PIC16F631/677/685/687/689/690 Family Silicon Errata and Data Sheet Clarification

The PIC16F631/677/685/687/689/690 family devices that you have received conform functionally to the current Device Data Sheet (DS41262E), except for the anomalies described in this document.

FIGURE 8-2: COMPARATOR C1 SIMPLIFIED BLOCK DIAGRAM

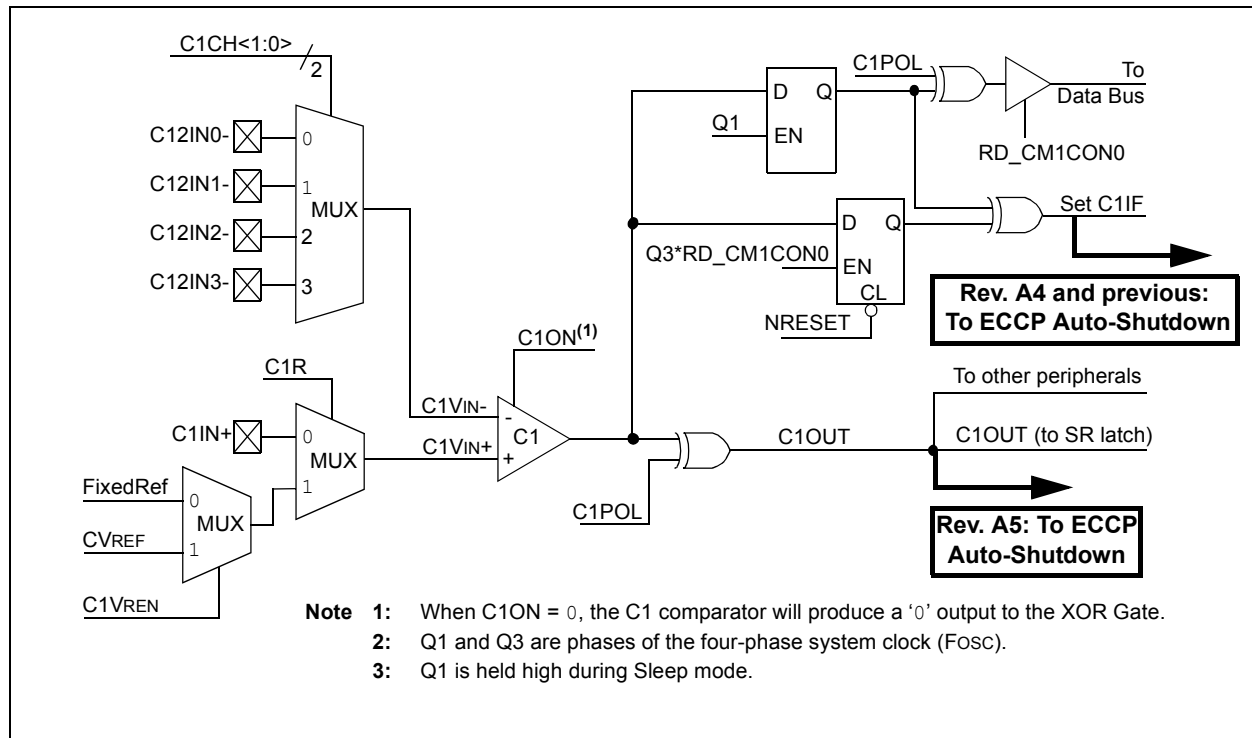
The PIC16F631/677/685/687/689/690 Rev. A4 silicon for the ECCP auto-shutdown is connected to the C1IF and C2IF flags. See Figures 8-2 and 8-3 on the following page.

The auto-shutdown connection (Rev. A4 and previous) to C1IF and C2IF causes the auto-shutdown to incorrectly operate synchronously. Additionally, reads of CMxCON0 will incorrectly clear an auto-shutdown event.

The Silicon Rev. A5 (now shipping) and later revision devices have moved the auto-shutdown connection from CxIF to CxOUT. This will eliminate the synchronous shutdown and simplify the use of the comparator for a shutdown event. Figure 1 shows the function of auto-shutdown before and after the device revision.
